ADDENDUM NO. 004

RE: Montgomery County Magistrate and Court Services Building
Montgomery County Board of Supervisors
T&L Project No. 16910
IFB No. 24-08

DATE: December 1, 2023

CSK - 01

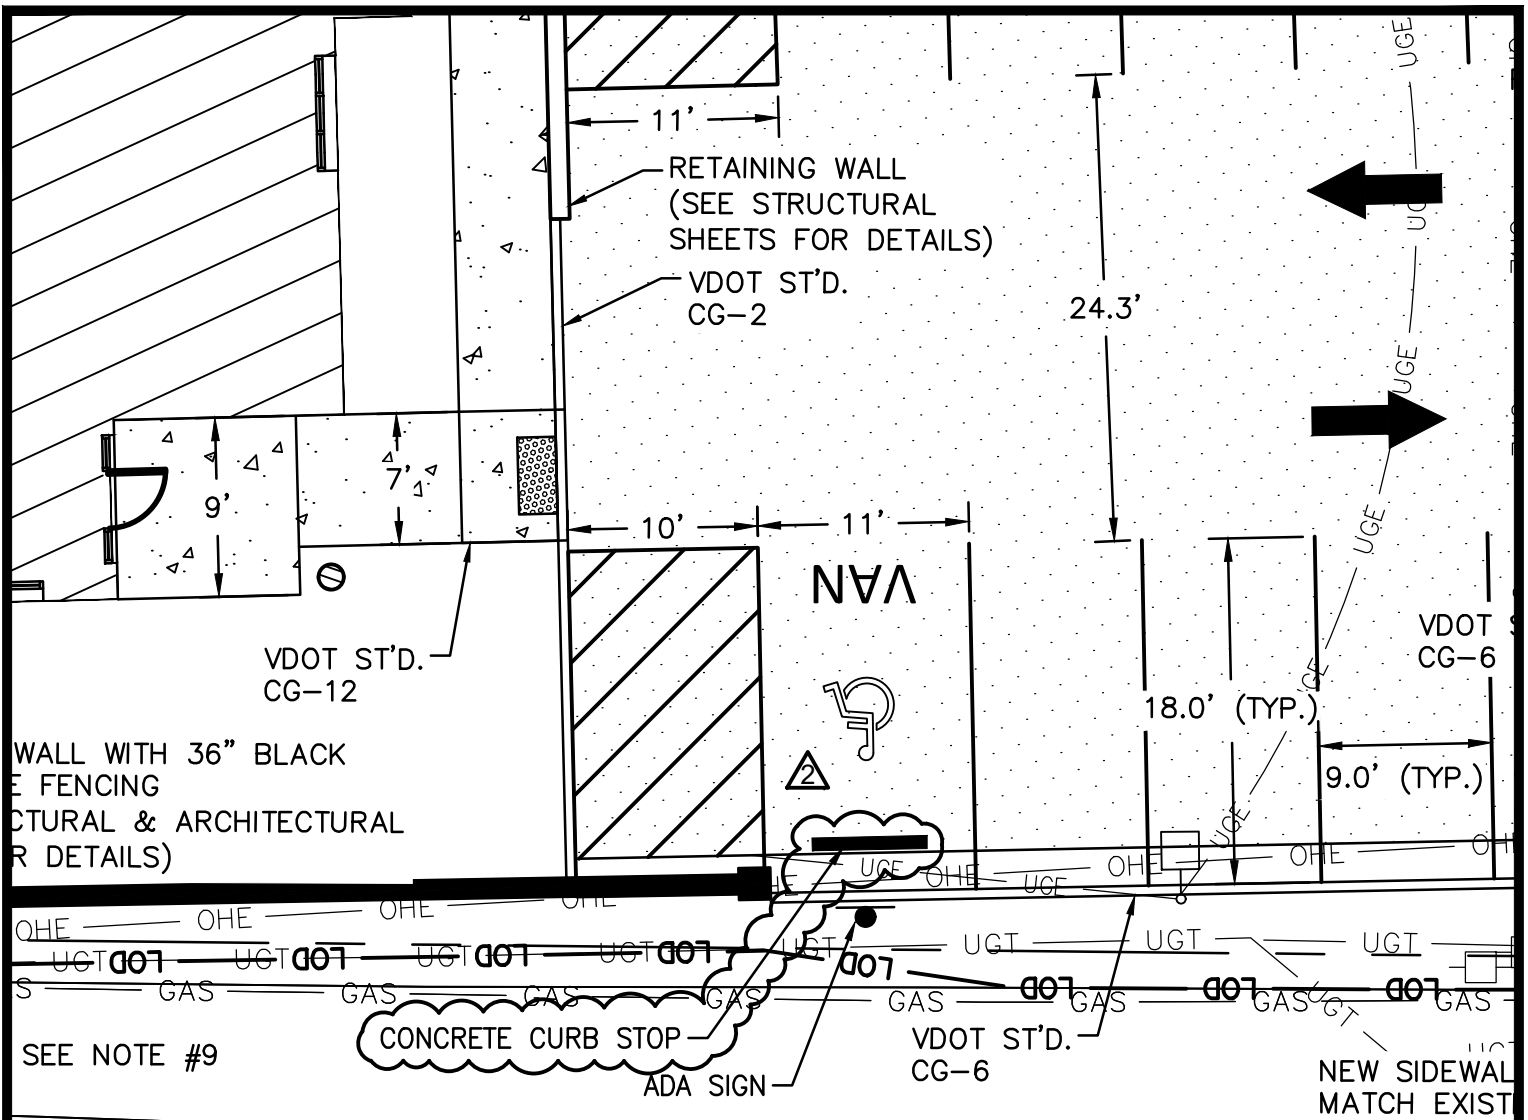
1. CSK-01: **ADDED** Curb stops.
2. CSK-02: **ADDED** Curb stops.
3. CSK-03: **ADDED** Tree protection.
4. ASK-01: **REVISED** 16A321.
5. ASK-02: **ADDED** Detail for Roof Access and Ladder in Storage C124.

Sheet C703 provides a typ. detail for curb stops. However, none are indicated on Sheet C300.

CSK - 03

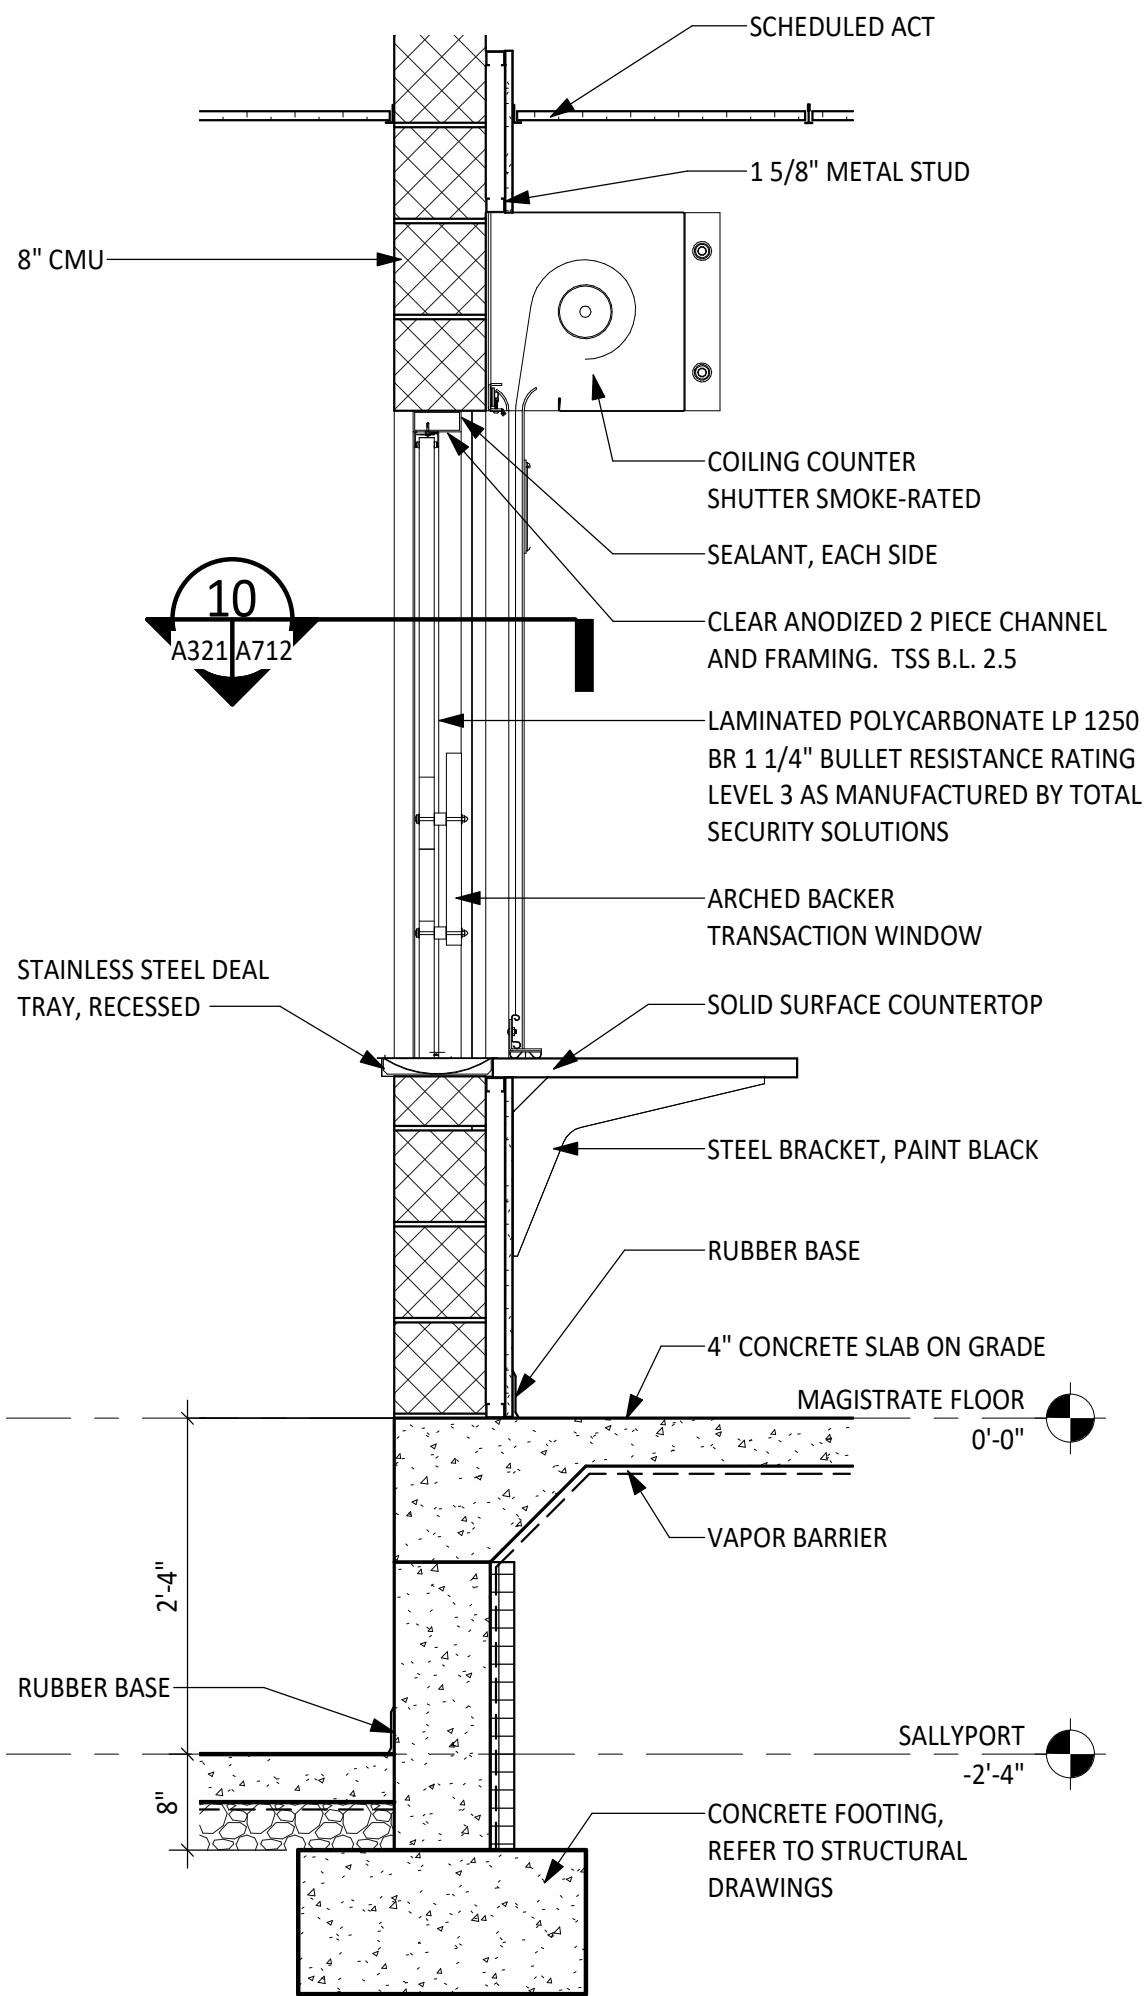
IF TREE IS EXTENSIVELY DAMAGED OR KILLED DURING CONSTRUCTION, THE TREE SHALL BE REPLACED, IN KIND, BY THE CONTRACTOR. THE CONTRACTOR SHALL COORDINATE TREE REPLACEMENT WITH THE TOWN TO DETERMINE THE CORRECT TYPE AND SIZE TO BE PROVIDED.

SKETCH
ASK-01

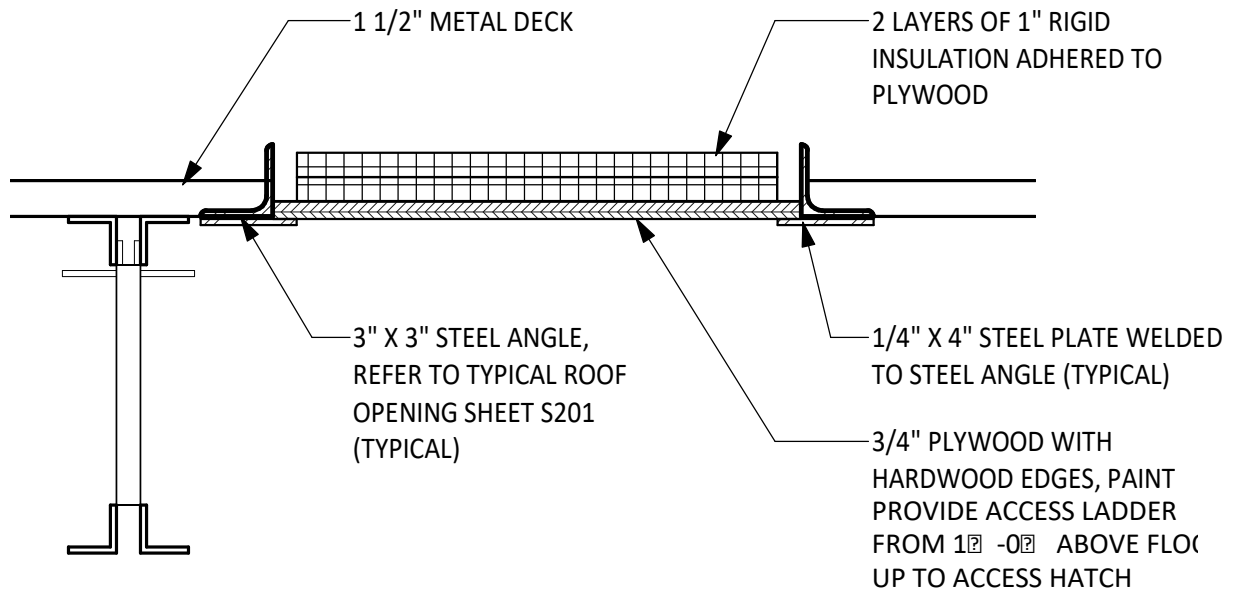
There is a conflict in the floor elevations shown in 16/A321 compared to section 8/S301. For the wall
shown in A102 that sits on top of the concrete foundation wall shown in 8/S301 and from the
viewpoint of rooms M119-M122, should there be 2'-4" of exposed concrete and then CMU? Please
clarify.

Refer to ASK-01 in Addendum No. 4 for Revised Section 16/A321. The concrete foundation
wall will be exposed and shall have a smooth rubbed finish per Specification Section 03
3000, Paragraph 3.7.C.

COMMUNICATION PLAN
1/8" = 1'-0"

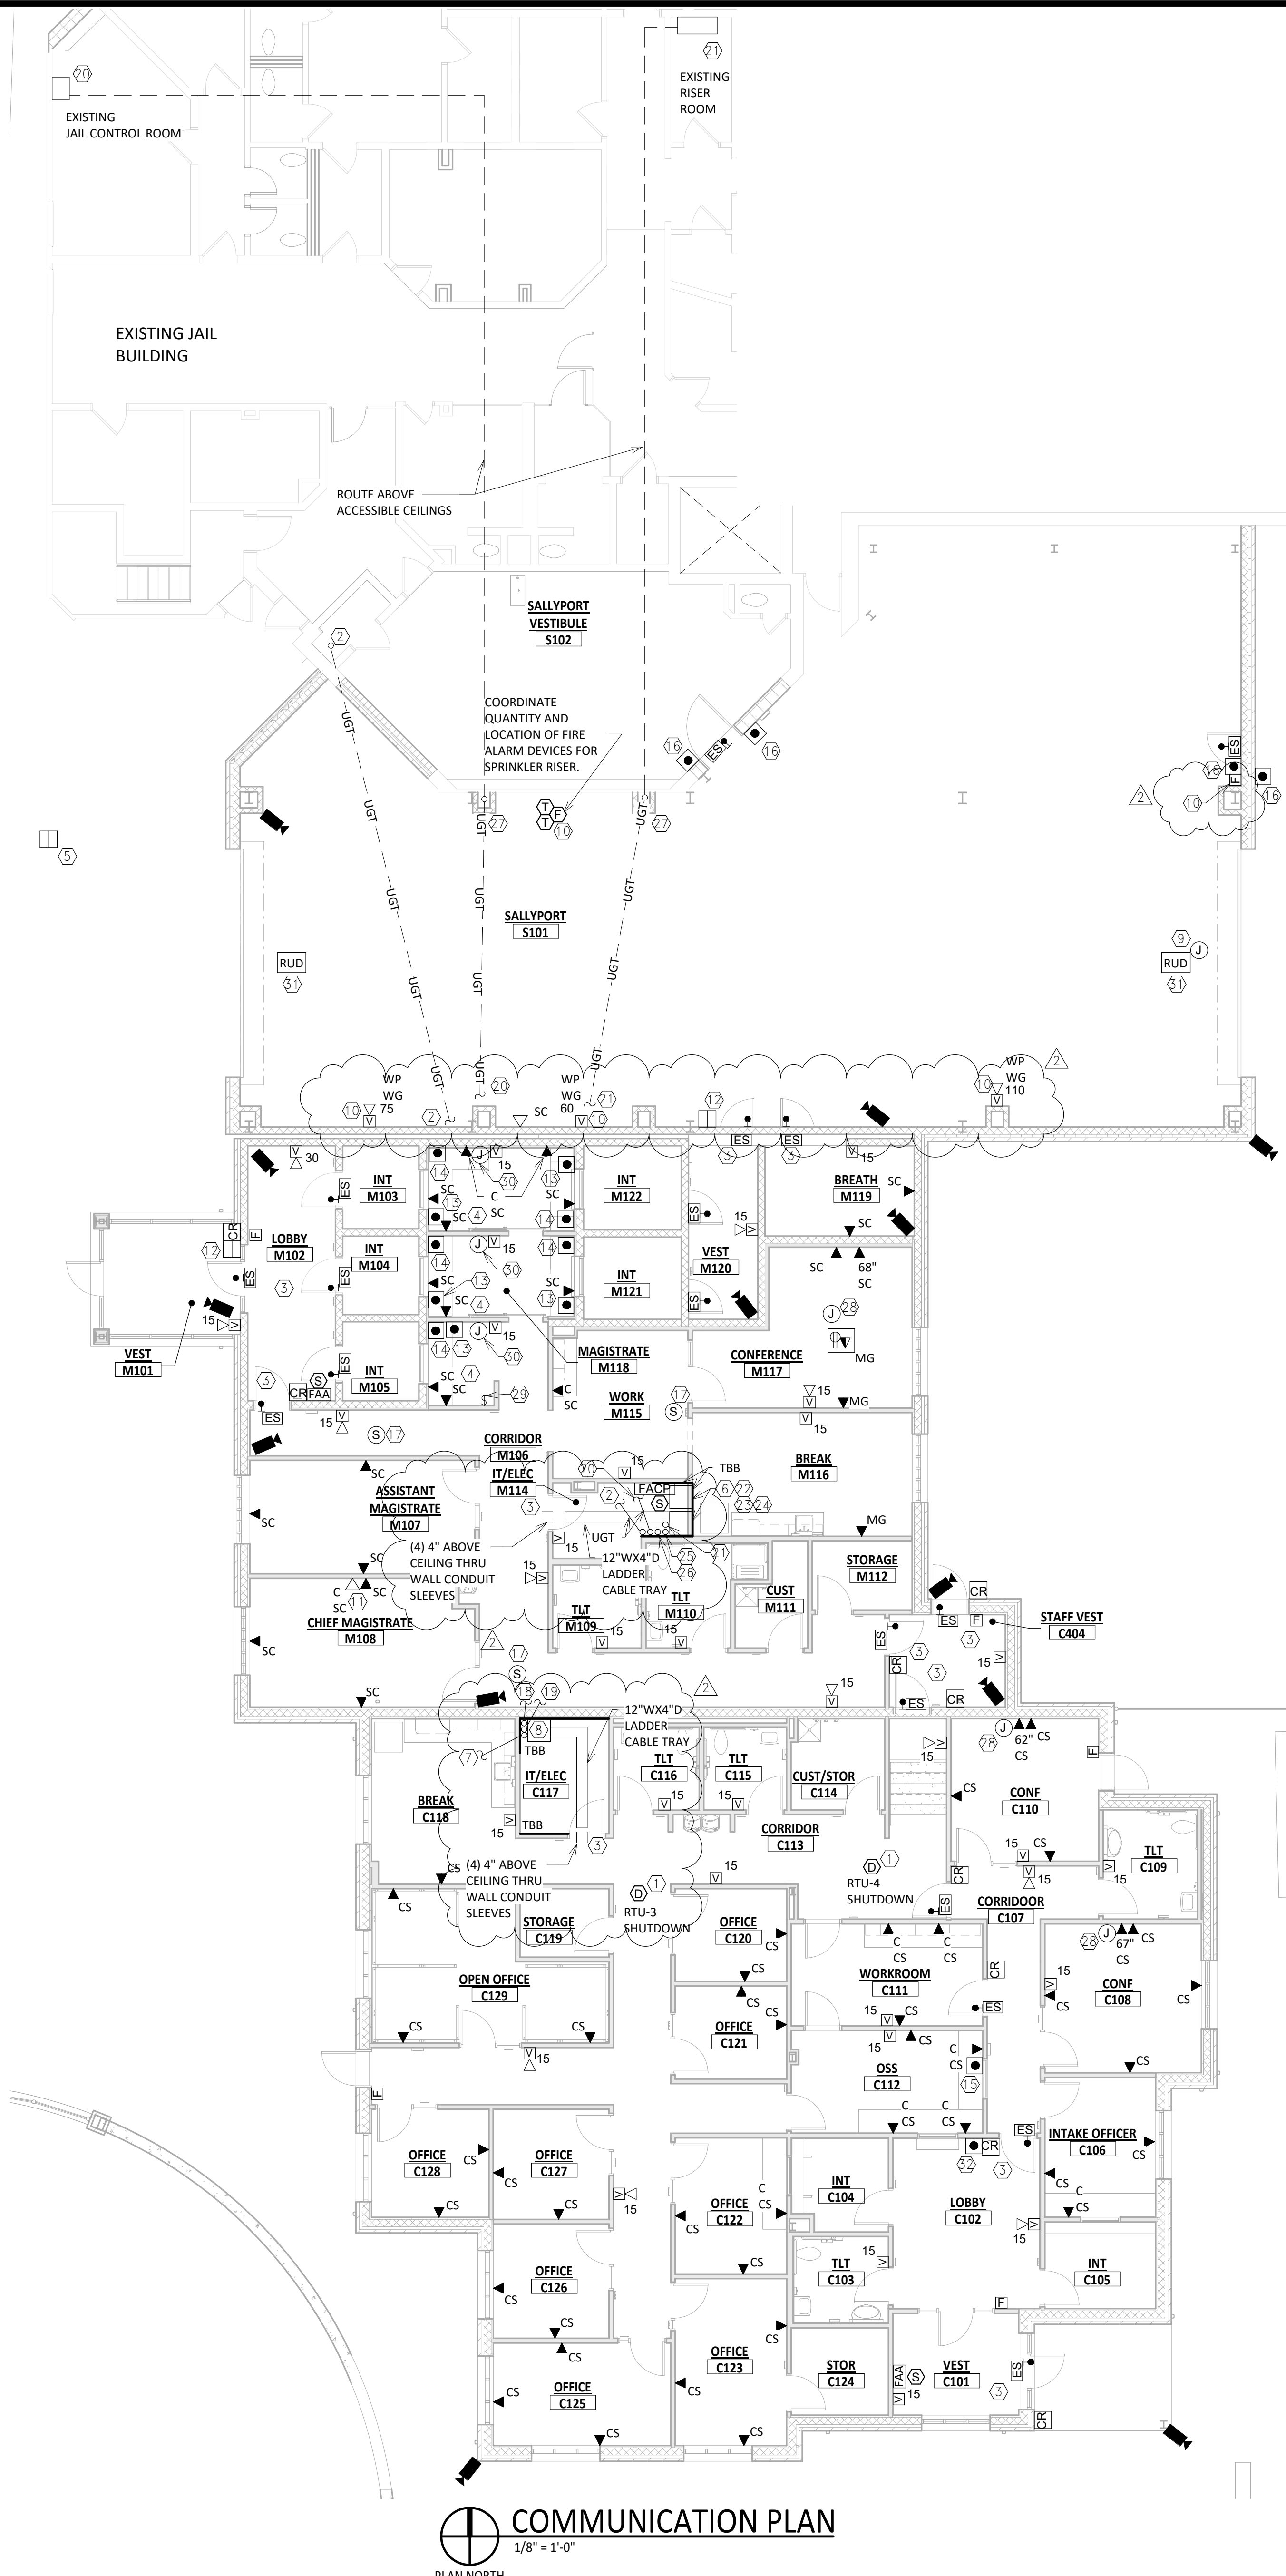
Date: 11/17/2023Project Name: Montgomery County Magistrate and Court Services BuildingT&L Project No.: 16910The following question concerns Drawing Sheet (number) E201:Keyed note #2 states to provide a POE network board for each access controllocation. Please clarify if these network boards are being provided under this contract,or the access control allowance specified in specification section 012100. If beingprovided under this contract, please provide additional information on this particularpiece of equipment (manufacturer, part number, etc.).
